FINAL DRAINAGE REPORT

PPR 234

Schubert Ranch Sand Resource Pit

Revised January 31, 2024

EL PASO COUNTY DEVELOPMENT PLAN
 EXISTING CONDITIONS
 FOR
 SCHUBERT RANCH SAND RESOURCE
 ELLICOTT, COLORADO

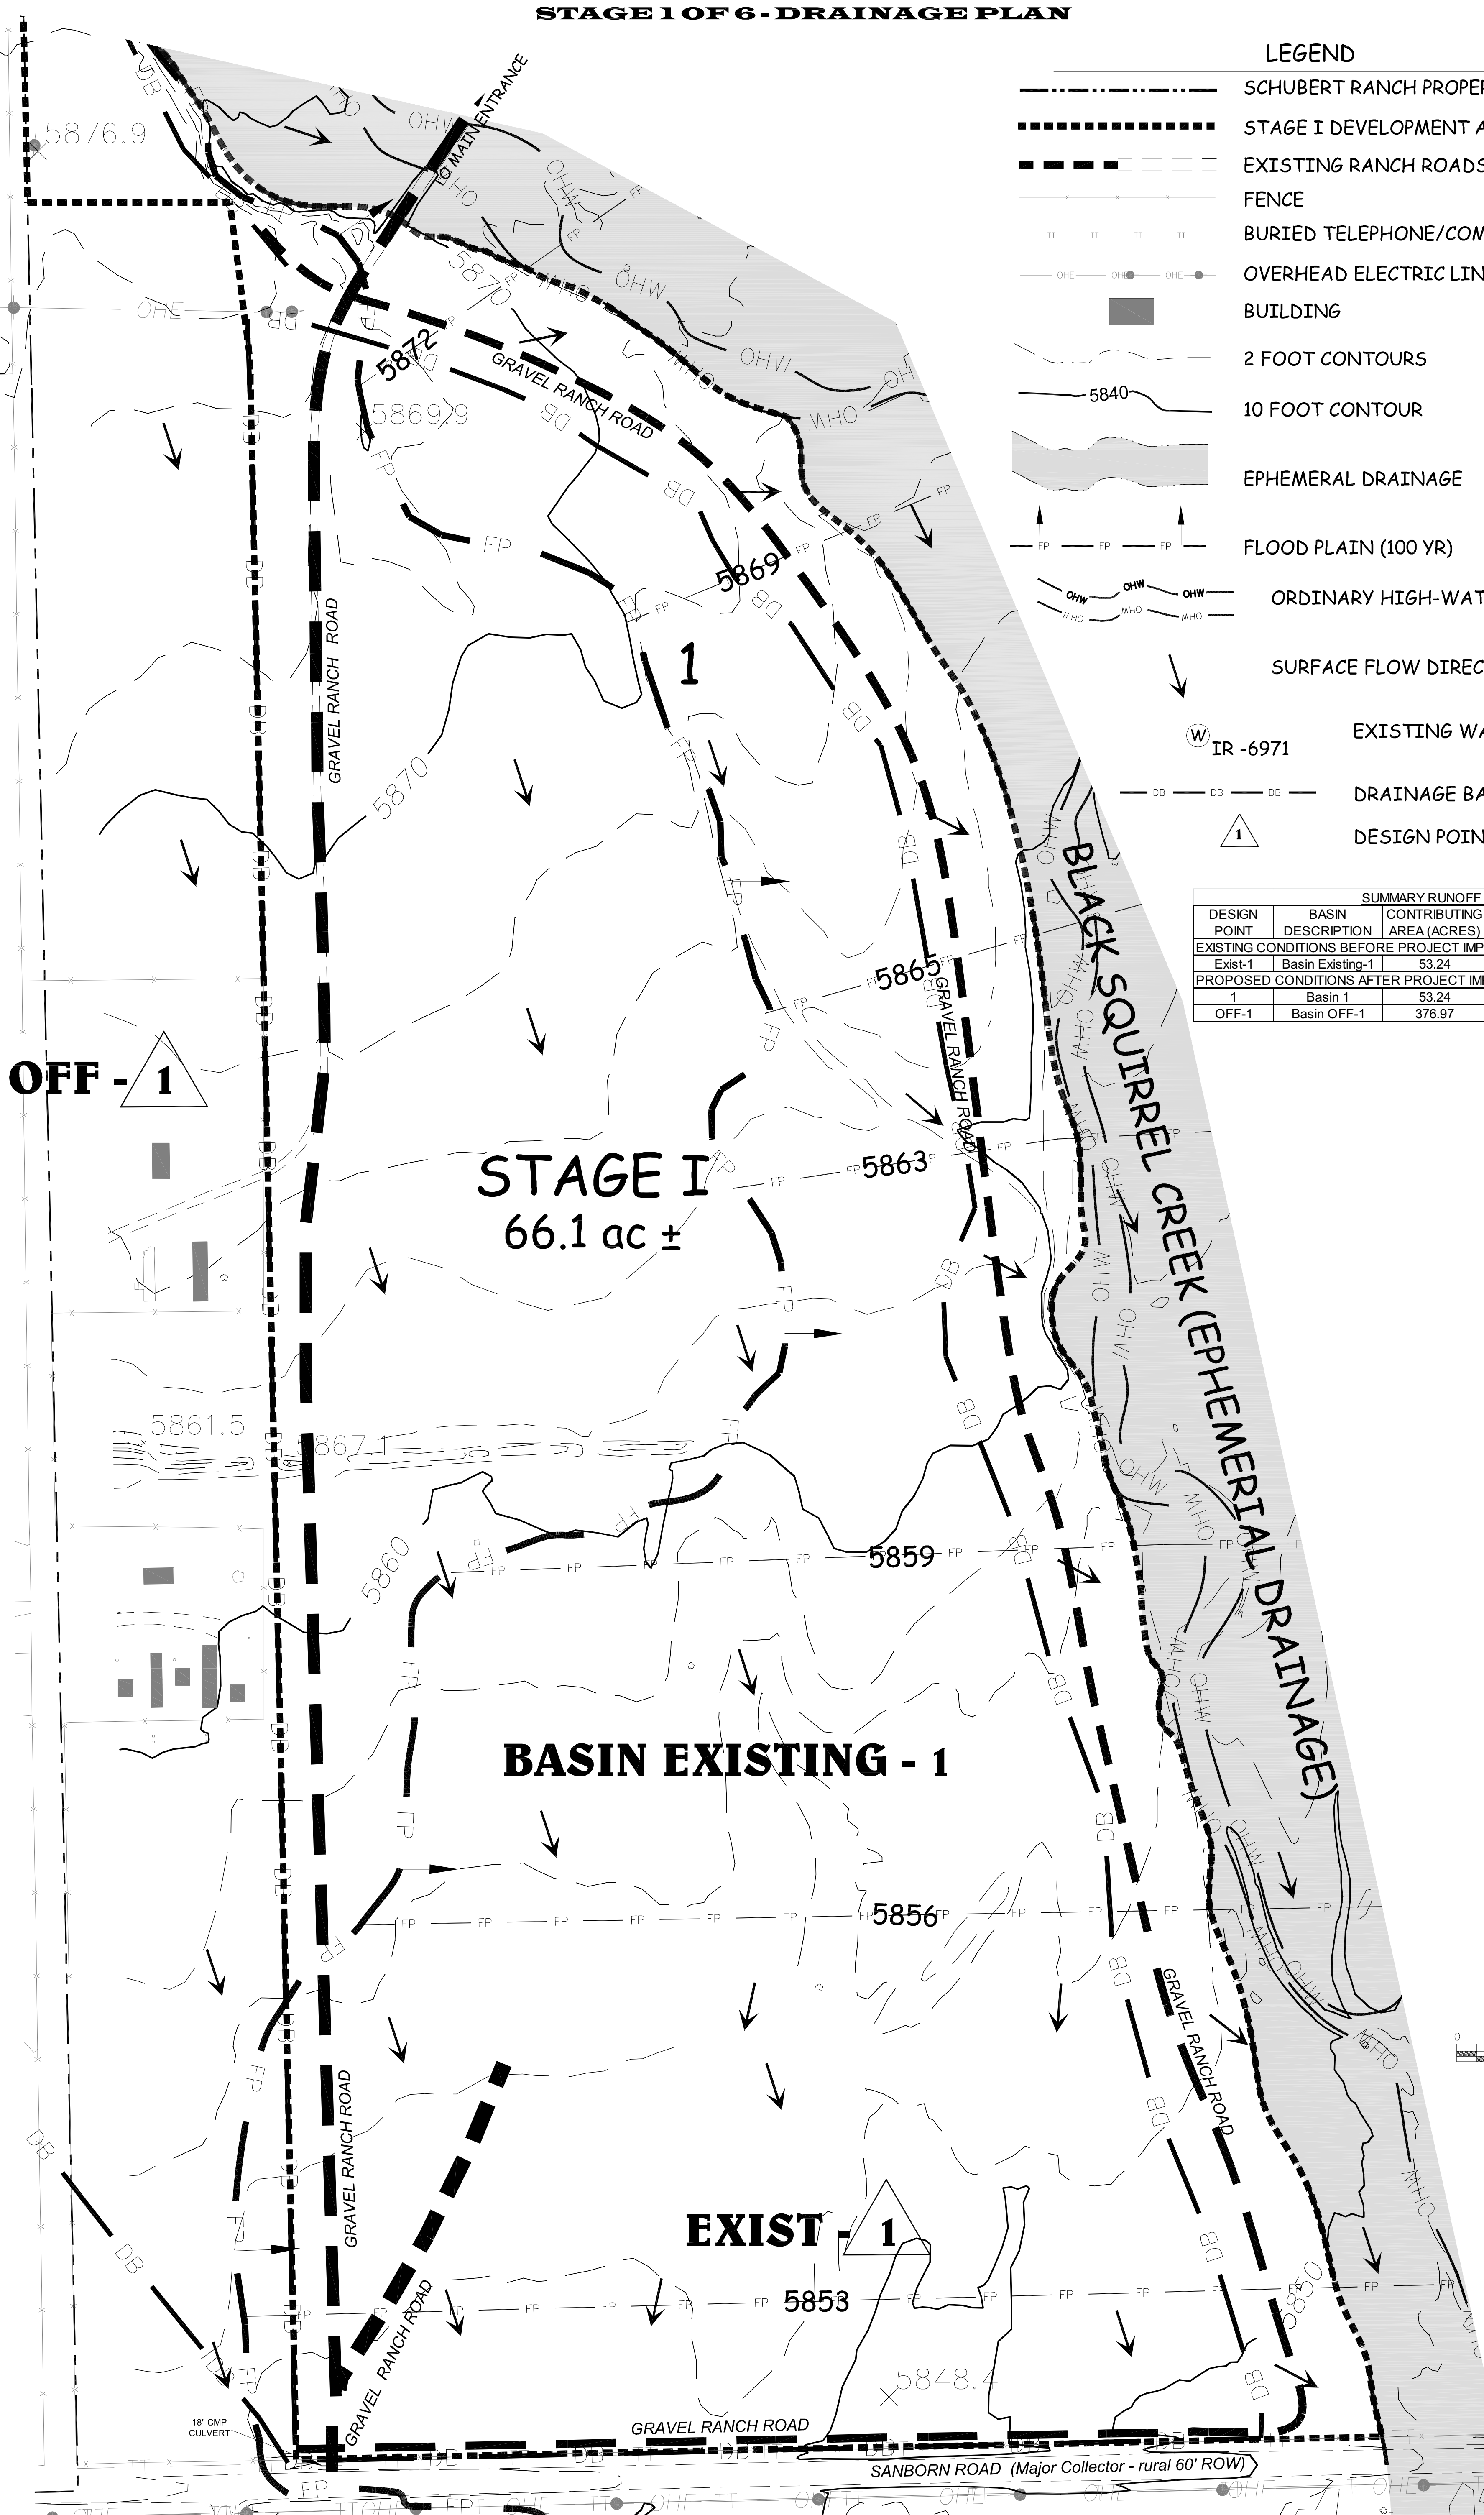
Please explain the increase in flows from existing to proposed as there is no development occurring that would increase the flows. Also see comment on drainage plan.

Flows for Basin 1 (the Stage I project area) were calculated for the existing conditions and proposed conditions for the 5-year design storm and the 100-year design storm. Flows for the offsite basin, Basin OFF-1, were calculated for the same storms for the proposed conditions (no change from the existing conditions). For Basin 1, existing conditions, the 5-year flow is 8.1 cubic feet per second (cfs) and the 100-year flow is 63.2 cfs. For Basin 1, proposed conditions, the 5-year flow is 12.9 cfs and the 100-year flow is 95.8 cfs. For Basin OFF-1, existing and proposed conditions, the 5-year flow is 45.9 cfs and the 100-year flow is 169.3 cfs.

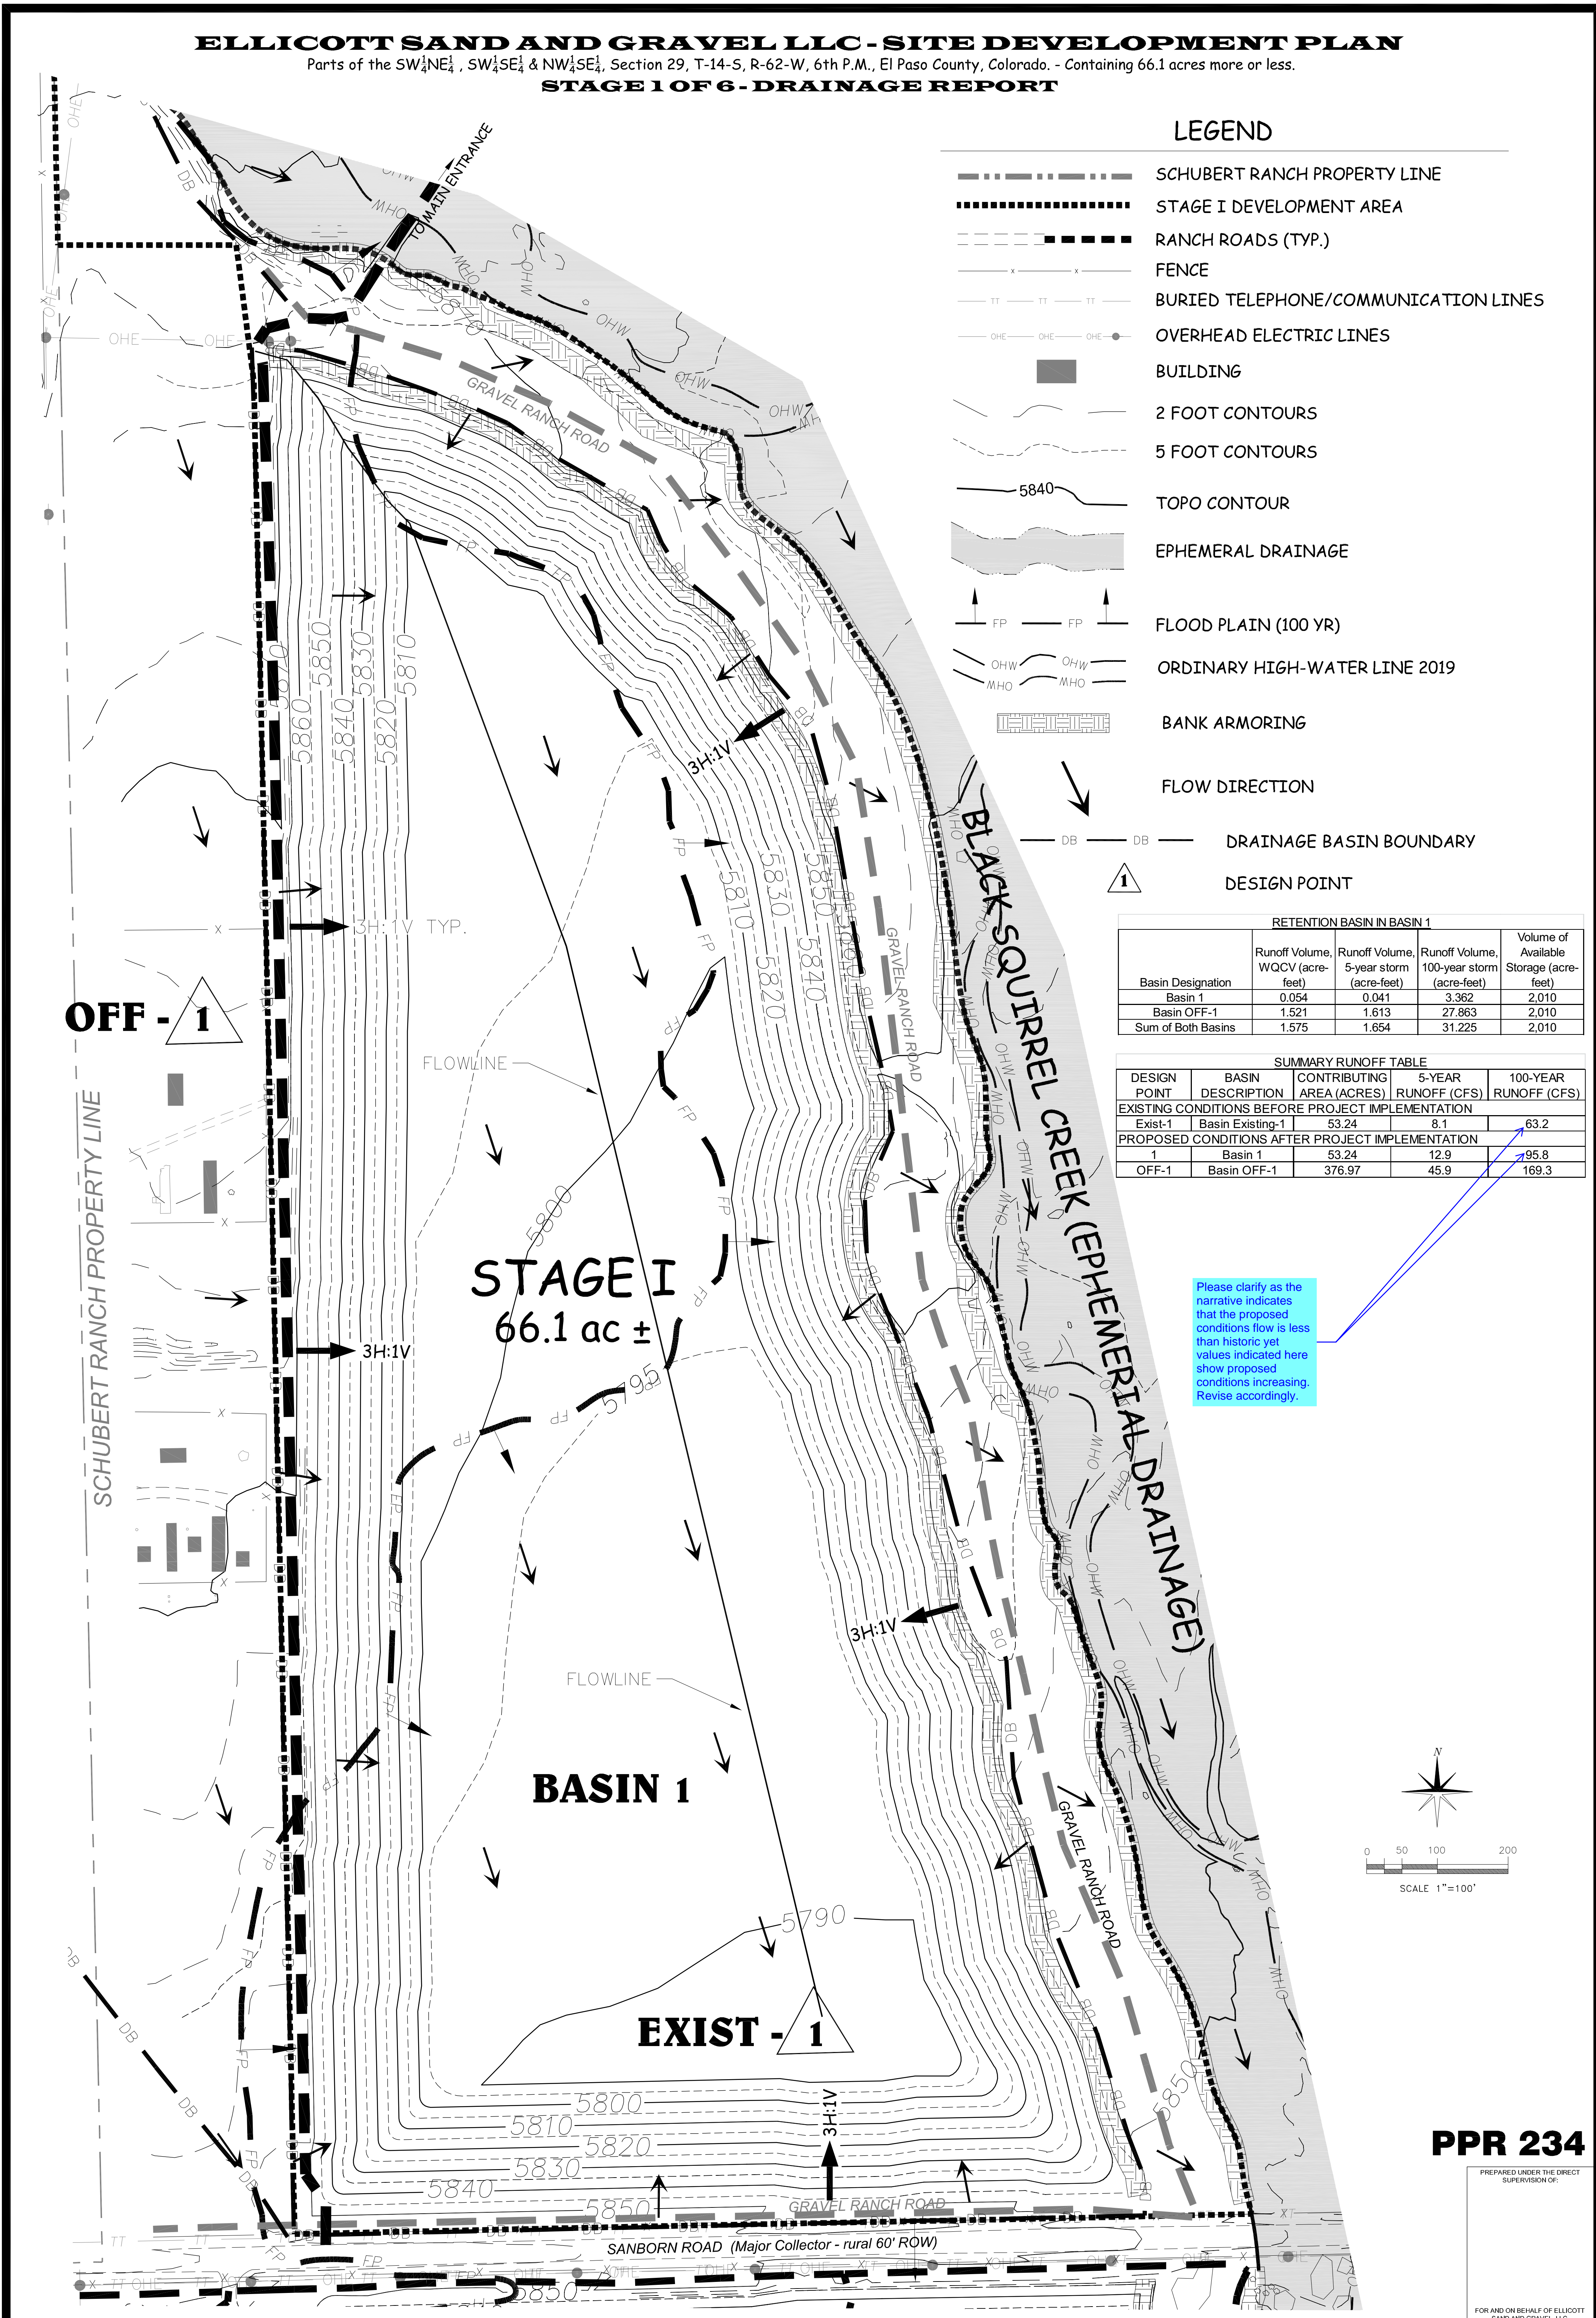
Please clarify as the narrative indicates that the proposed conditions flow is less than historic yet values indicated here show proposed conditions increasing. Revise accordingly.
